February 12, 2014

RE: Letter of Notification for the Ohio Central 138kV Loop Project Case No. 14-0053-EL-BLN

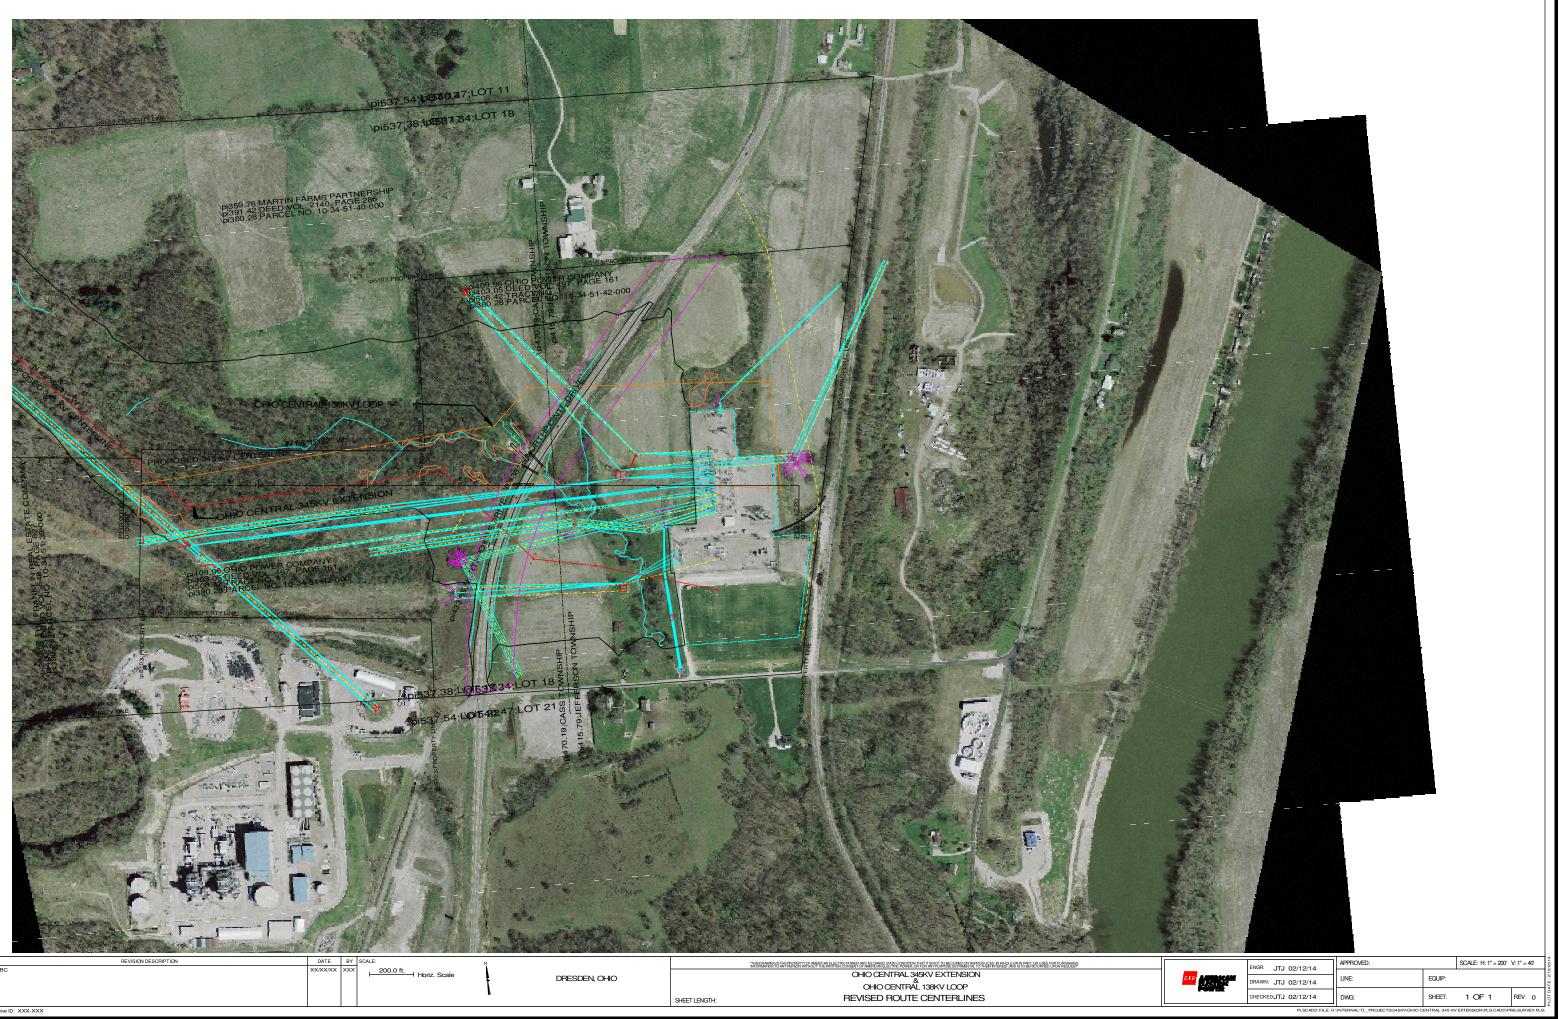
During finalization of the engineering for the two routes, the height of the structures became a concern. The need to cross over the existing transmission lines entering Ohio Central Station necessitated the use of taller structures. In the original design, the 138kV line was routed parallel to the 345kV line, but was positioned to the south of the 345kV line and to the west of Northpointe Drive. This design caused the 138kV line to cross over two other existing 138kV lines while at the same location, crossing under the new 345kV line at Northpointe Drive. The height of the existing tower lines would have caused the new 345kV structures to be well over 200-feet high, which would have caused the need to obtain FAA permits, and the potential for lighting and painting of the structure. In switching the location of the two lines in the parallel alignment and slightly realigning the routes, the structure heights were lowered and kept below 200-feet in height. The revised alignment also allows more of the centerline to be routed on existing AEP property, which reduces the need for additional easements. This new alignment also eliminates the need for one 345kV structure to the west of Northpointe Drive. All structures will be located

The attached map details the change to the alignment of the 345kV line and the 138kV line. A revised copy of the Erosion and Sediment Control map sheet will be provided to Staff under separate cover.
